# DECK PLANS

Stillwater  
Building Inspection  
651-430-8823  
www.ci.stillwater.mn.us

# DOES THIS PLAN LOOK ACCEPTABLE?

**THIS IS NOT A SITE PLAN!**

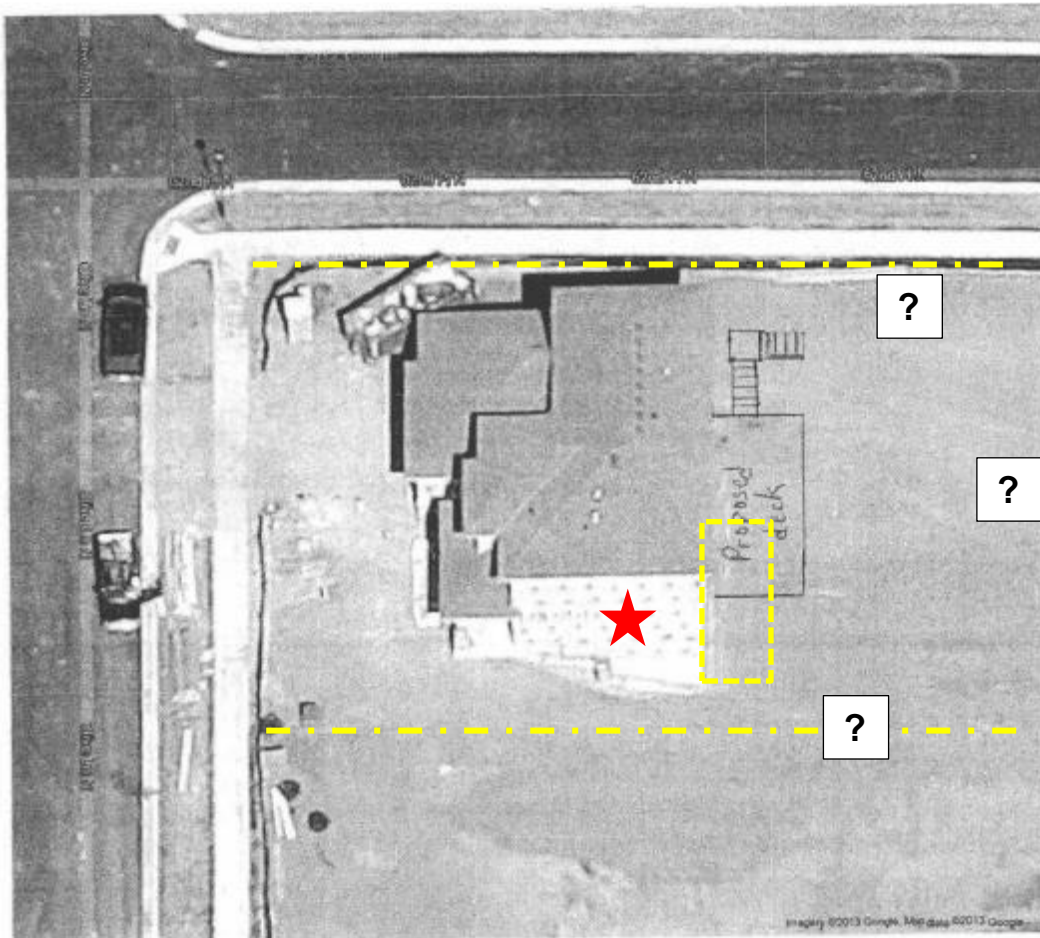
- NO LOT LINES ARE SHOWN
- THE DASHED YELLOW LINES HAVE BEEN ADDED FOR INFORMATIONAL PURPOSES AND ARE THE APPROXIMATE LOCATION OF THE SIDE LOT LINES.
- NO DIMENSIONS ARE SHOWN (LOT, EXISTING BUILDINGS, PROPOSED DECK)
- HOW FAR DO YOU THINK THIS DECK IS FROM LOT LINES?
- ★ THE PHOTO IS AN OBLIQUE VIEW OF THE DWELLING. THIS IS ACTUALLY THE SIDE OF THE HOME.
- IT APPEARS THAT THE DECK MAY BE SOME DISTANCE FROM LOT LINE WHEN IN FACT IT WAS BUILT TO THE EDGE OF THE DWELLING (ABOUT 8 FEET FROM THE LOT LINE).
- BECAUSE THE PHOTO IS AN OBLIQUE VIEW, IT IS IMPOSSIBLE TO DETERMINE THE APPROXIMATE LOCATION OF THE PROPOSED DECK FROM THE PHOTO.
- THE YELLOW DASHED RECTANGLE IS A CLOSER ESTIMATE OF THE LOCATION OF THE DECK.

**THIS IS NOT A FLOOR PLAN!**

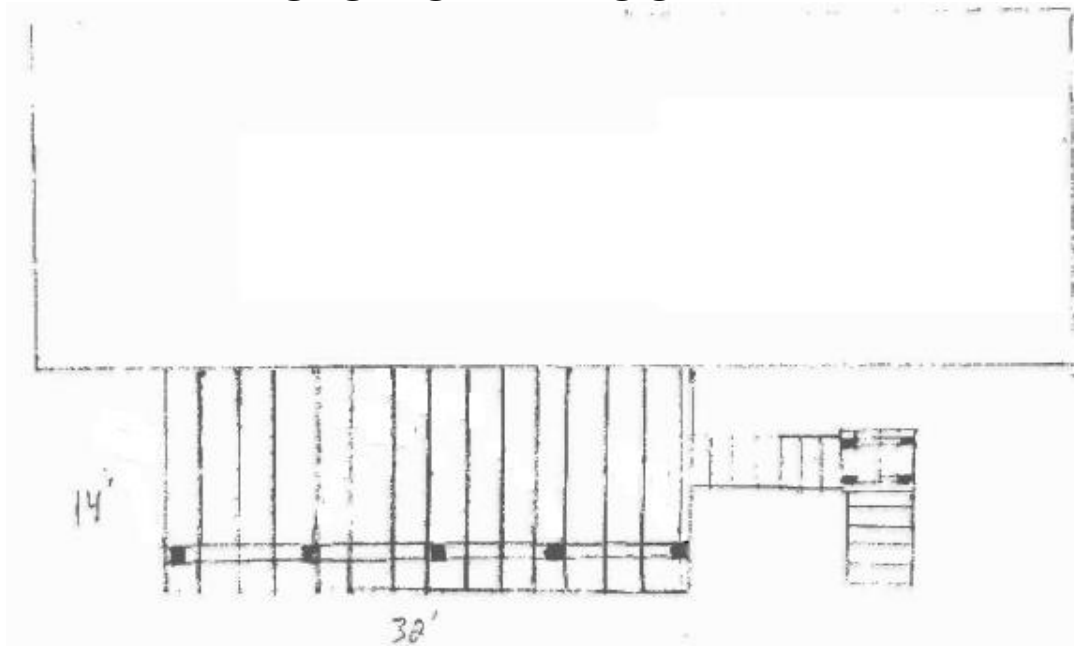
- THIS IS A SKETCH AND NOT A FLOOR PLAN
- THE PLAN SHOWS THE DECK SOME DISTANCE FROM THE LEFT LINE OF THE DWELLING. IT WAS ACTUALLY BUILT TO THE DWELLING LINE.

- THE PLAN DOES NOT APPEAR TO SHOW THE BEAMS CANTILEVERED AT THE ENDS. IT WAS ACTUALLY BUILT WITH CANTILEVERS OF ABOUT ONE FOOT.
- NOTES ELSEWHERE INDICATE JOIST SPACING OF 16" O.C. THIS PLAN SHOWS SOMETHING IN EXCESS OF 24" O.C.

- NO DIMENSIONS REGARDING CANTILEVER
- NO DIMENSIONS REGARDING COLUMN LOCATIONS
- NO ATTACHMENT DETAILS FOR STAIRS
- NO INFORMATION REGARDING LANDING
- NO INFORMATION REGARDING DISTANCE FROM STAIRS AND LANDING TO DWELLING PROVIDED

- NO INFORMATION REGARDING LEDGER MATERIAL OR METHOD OF ATTACHMENT
- NO INFORMATION REGARDING SIDING AND SHEATHING ON DWELLING
- NO INFORMATION REGARDING FLASHING

- NO ELEVATION PROVIDED
- NO INFORMATION ON ADJOINING GLAZED OPENINGS PROVIDED
- NO HEIGHT ABOVE GRADE PROVIDED
- HOW CAN FOOTING SIZES BE DETERMINED FROM THIS SKETCH?

# DOES THIS PLAN LOOK ACCEPTABLE?

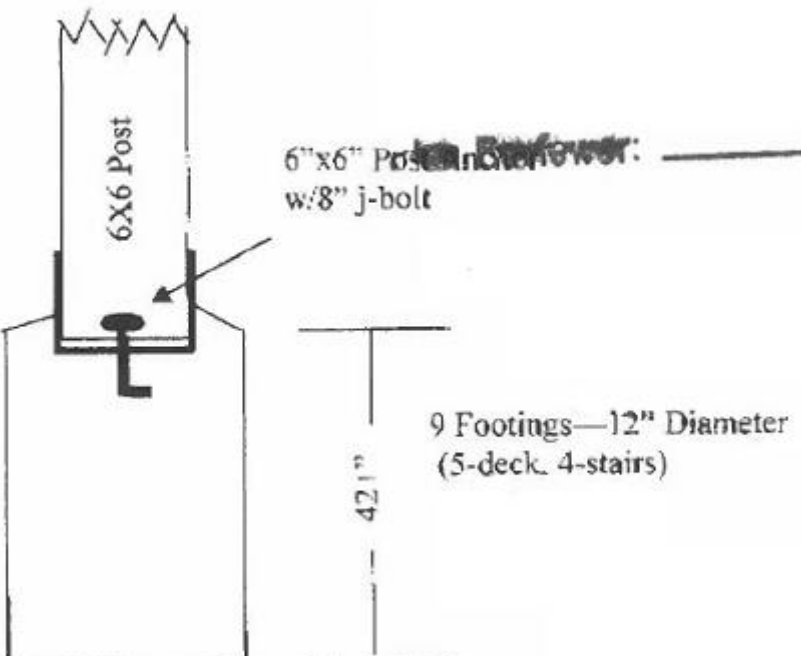
<p><b>Information</b></p> <p>Framing: Treated—2X10          Joists—16" OC          Posts—Treated 6x6          Beam—2-2x10          Decking: 5/4" UltraDeck composite          Cantilever: 16", 12" on ends          Joist Hangers: Galvanized          Fasteners for Ledger: Ledgerlok          UltraDeck rail with alum. spindles          Triple coated deck screws          Stair Treads: 2-5/4" UltraDeck composite          Stair joists—12" OC</p>	<ul style="list-style-type: none"> <li>• CANTILEVER INTENT NOT CLEAR</li> <li>• HANGER MATERIAL NOT CONSISTENT WITH WOOD TREATMENT</li> <li>• NO SPECS ON LEDGER</li> <li>• NO SPECS ON FLASHING</li> <li>• SPECS ON LEDGERLOKS NOT PROVIDED</li> <li>• LOCATION OF LEDGERLOCKS NOT PROVIDED</li> <li>• NO INFORMATION ON FLOOR FRAMING OF DWELLING TO WHICH LEDGER ATTACHED</li> <li>• NO SPECS ON RAILING</li> <li>• NO INSTALLATION INSTRUCTIONS FOR RAILING</li> <li>• NO SPECS FOR STAIR STRINGER MATERIAL</li> </ul>

<p><b>Beam to Post Detail #2</b></p> 	<ul style="list-style-type: none"> <li>• METHOD OF CONNECTING BEAM TO COLUMN NOT SPECIFIED OR IDENTIFIED</li> <li>• HEIGHT OF COLUMN NOT INDICATED</li> </ul>
<p><b>Footing Detail</b></p> 	<ul style="list-style-type: none"> <li>• IS THE POST REALLY INSERTED INTO THE FOOTING?</li> <li>• WHAT IS THE METHOD USED TO ANCHOR THE POST TO THE FOOTING?</li> <li>• HOW WAS THE SIZE OF THE FOOTINGS DETERMINED?</li> <li>• WHERE IS GRADE?</li> </ul>

# DOES THIS PLAN LOOK ACCEPTABLE?

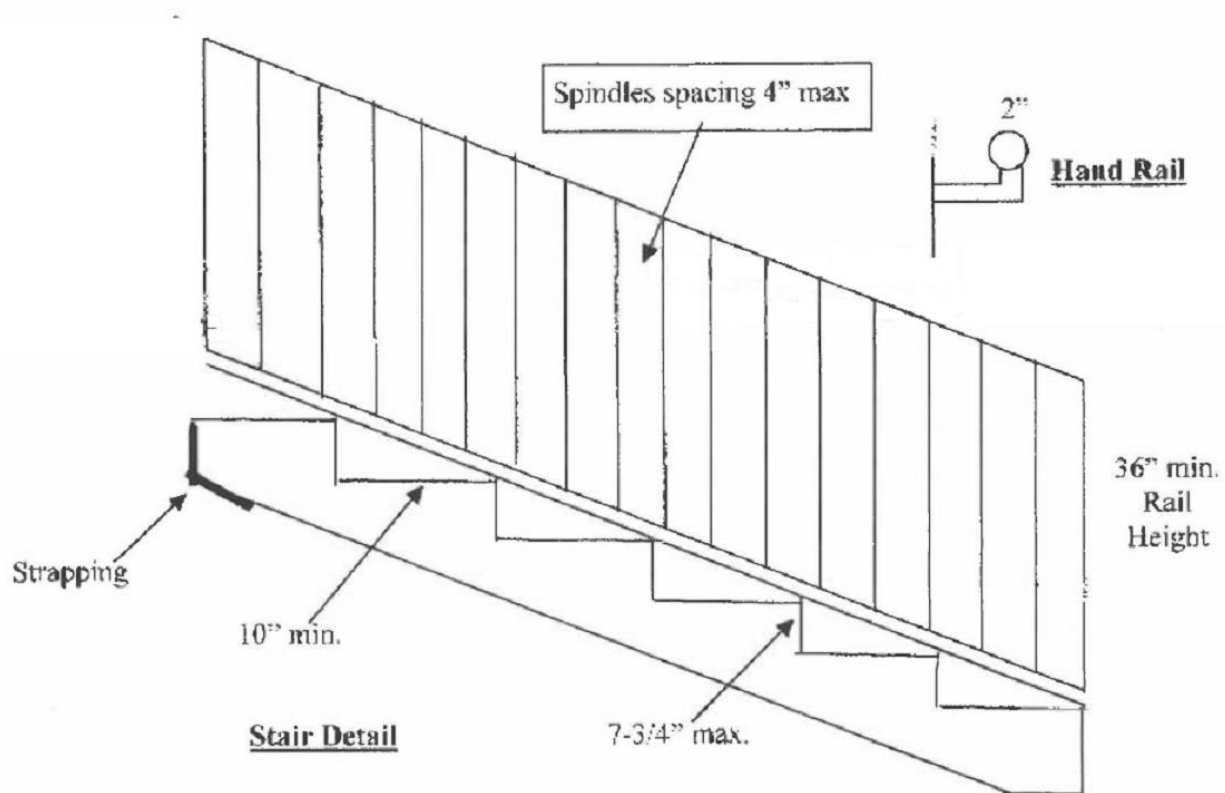
- IF THE RISERS ARE AT THE 7 ¾" MAXIMUM, THE RUN SCALES TO 24"
- WHAT IS "STRAPPING"?
- HOW WILL THE "HAND RAIL" CONNECT TO THE "RAIL"?
- AT WHAT ELEVATION WILL THE "HAND RAIL" BE?
- WHAT IS THE TOTAL RISE OF THE STAIRS?
- WILL OPEN RISERS BE USED?
- HOW WILL THE STRINGERS BE ATTACHED TO THE DECK?
- WILL THE BOTTOM RISER ACTUALLY BE 50% HIGHER THAN THE OTHER RISERS?
- HOW MUCH SPACE WILL OCCUR IN THE TRIANGULAR AREA BETWEEN TREAD, RISER, AND BOTTOM OF RAIL?
- HOW WILL THE RAIL BE SECURED TO THE STAIRS?
- ARE RAILS PROPOSED FOR BOTH SIDES OF THE STAIRS AND FOR BOTH FLIGHTS?
